Application to Amend
Materials License 20-32465-02E
and
SS&D NR-1101-D-102-E
to add
TIMON and OrthoTIMON

Response to NRC Letter dated March 2, 2015

SUBJECT: Your letter dated March 2, 2015, Request for additional information; Bruker Amendment
request dated January 2, 2015

RAID & TIMON Measuring Tube Contrast and Comparison

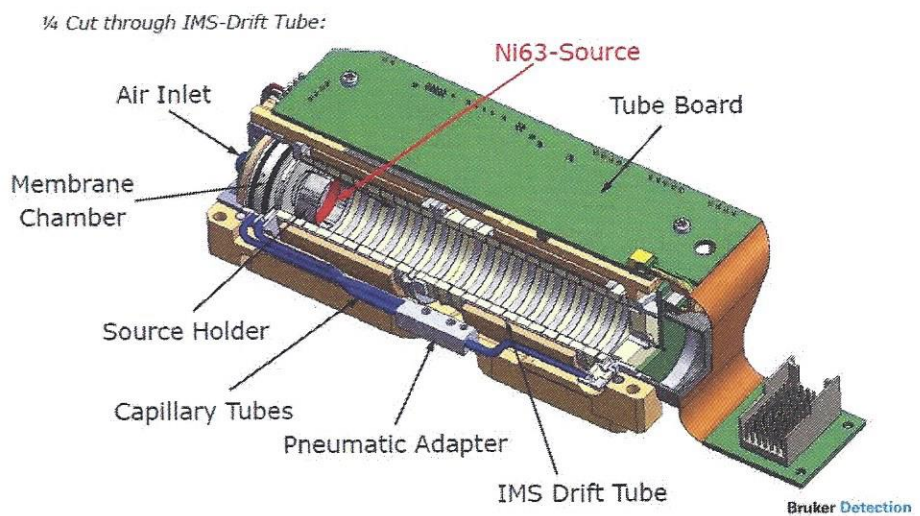
6. *In the RAID Series. Please provide a description of the similarities and differences between the appropriate RAID Series of devices and TIMON and OrthoTIMON models, as well as similarities and differences between the TIMON/OrthoTIMON IMS detection cell/"measuring tube" and the RAID Series IMS detection cell/"measuring tube". A table format is preferred.*

Response: RAID & TIMON Devices Contrast and Comparison

RAID device Measuring Tube	TIMON/OrthoTIMON Measuring Tube
General design	Similar to TIMON/OrthoTIMON	Similar to RAID devices
Construction elements	Similar to TIMON/OrthoTIMON	Similar to RAID devices
Technology of the IMS tube manufacturing	Soldering	Gluing

Measuring Tube Source Location

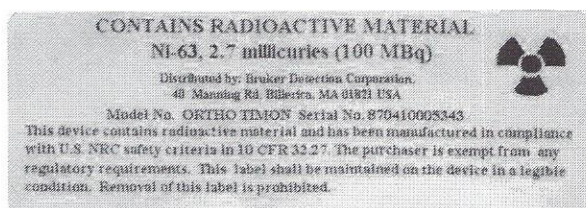
8. Please provide an engineering drawing that shows the cross sectional view of the "measuring tube" shown in Drawing Number "OR 0100 G 003" in Attachment E. The drawing can be similar to the drawing of the IMS detection cell included in Attachment 4 of your current Registration Certificate NR-1101-D-102-E.

Response: See Attached D, "Measuring Tube Source Location, TIMON and OrthoTIMON".

Distribution Label

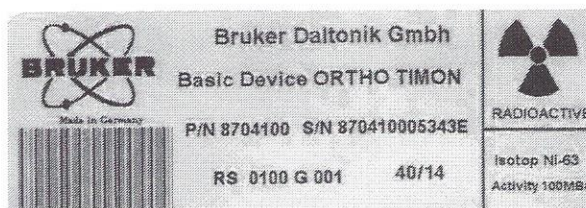
10. On Page 7, you provided copies of the labels that will be located on the right side cabinet. Please note that the label shown in "Figure 1- Source Information Label, Cabinet Surface," contains your former distributor name "Bruker Daltonics NBC Detection Corporation." Please provide a copy of the label with the current distributor name and address.

Response: New labels ----- The name has been corrected

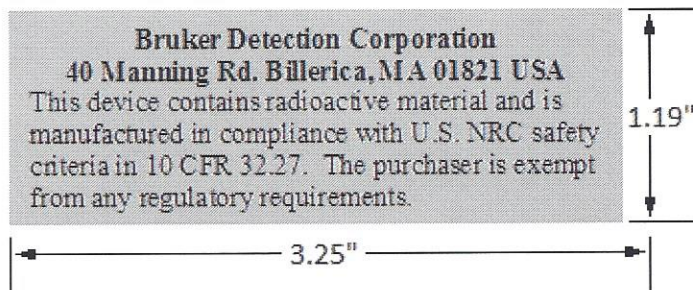
24. *10 CFR 32.29(b)(1)(i) requires that each person licensed under 10 CFR 32.26 shall label or mark each detector so that each detector has a durable, legible, readily visible label or marking on the external surface of the detector containing the following statement: "CONTAINS RADIOACTIVE MATERIAL."*

Contrary to the above, the device labels submitted in section 4.1 of your application do not meet the requirement of 10 CFR 32.29(b)(1)(i).

Please provide labels, copies of labels, or markings that meet the requirement in 10CFR32.29(b)(1)(i).

Response: Corrected. See the "Distribution Label" above.

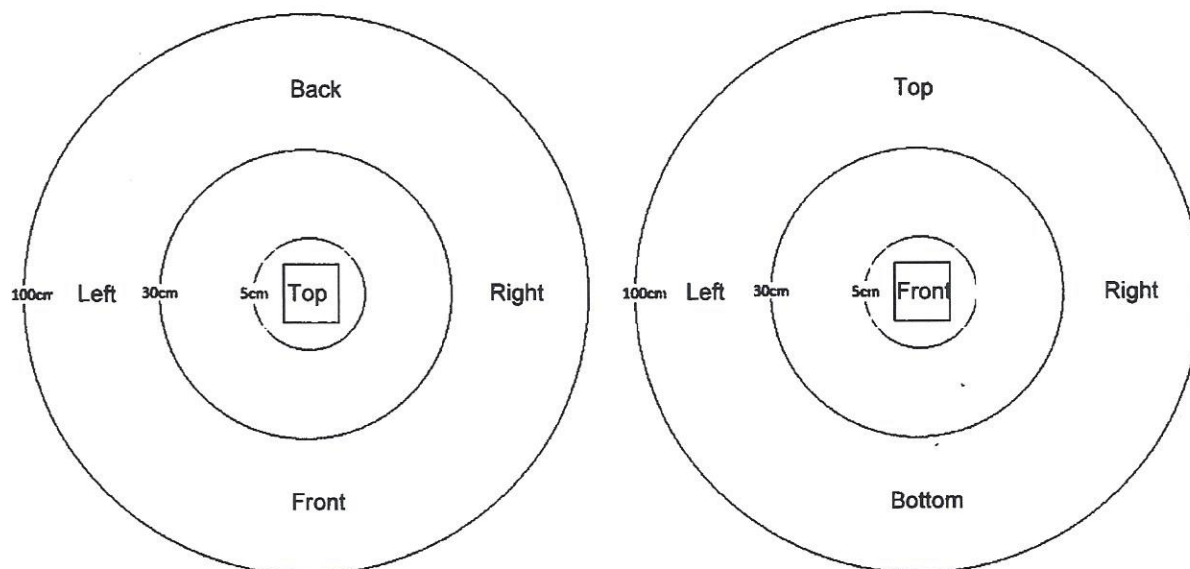
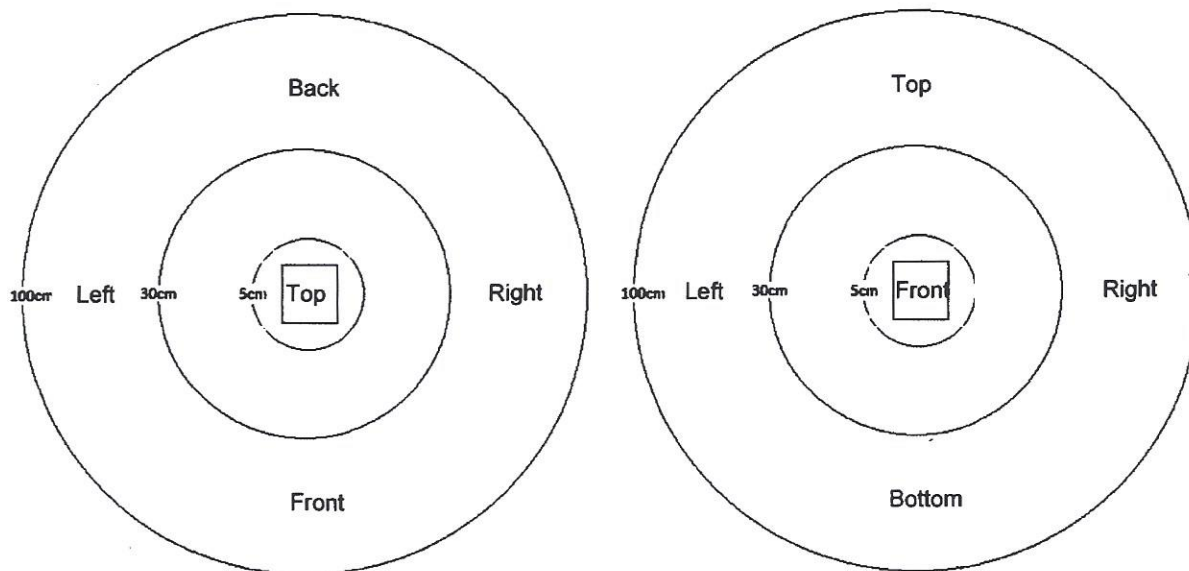
19. *The radiation profiles provided in Attachment G of your amendment request identify the Model surveyed as TIMON. Please clarify if both TIMON and OrthoTIMON device models were surveyed. If only the TIMON device model was surveyed, please explain why only this model was surveyed and how the radiation profiles are applicable to the OrthoTIMON device model. If the OrthoTIMON device model was surveyed, please provide the radiation profiles.*

Response: See Attachment G radiation profiles for the OrthoTIMON.

Figure 2. Drawing of portion of TIMON interior showing the protected location of the ^{63}Ni source within the IMS tube.

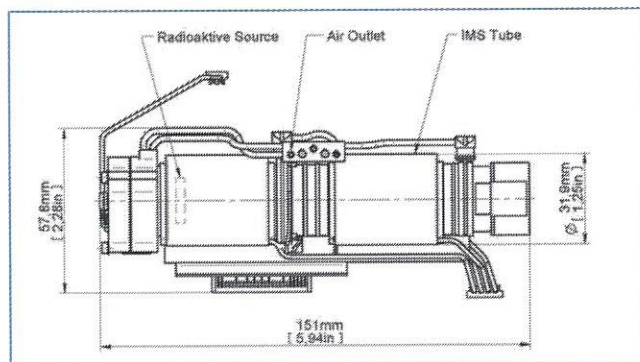
Question 26. 10 CFR 32.27 requires that an applicant for a license under 10 CFR 32.26 shall demonstrate that the product is designed and will be manufactured so that the requirements of 10 CFR 32.27 are met.

Please provide additional information for the Bruker TIMON and OrthoTIMON devices to demonstrate that these products are designed and will be manufactured so that each of the specific safety criteria in 10 CFR 32.27 are met. In preparing your response, you should address each of the specific circumstances described in 10 CFR 32.27. You may wish to consult section 2.15 of NUREG-1717, Systematic Radiological Assessment of Exemption for Source and Byproduct Materials, which provides guidance on meeting the safety criteria of 10 CFR 32.27.

External Radiation Dose: There is no detectable particle or photon radiation outside the metal case in which the TIMON is contained. There is also no detectable radiation outside the IMS tube which surrounds the radioactive source inside the TIMON case. Therefore there is no individual or group likely to receive *any* direct radiation from one or any larger quantity of these devices in normal handling and storage of the quantities of exempt units likely to accumulate in one location during marketing, distribution, installation, and servicing of the product.

While servicing the product there is no need for the technician to access the interior of the IMS tube that contains the radioactive source. Accessing the source would require destruction of the IMS tube. It is therefore unlikely that the external radiation dose in any one year, to any individual or group of individuals expected to be most highly exposed to radiation or radioactive material from the product will exceed the doses listed in rows a and b in the table below.
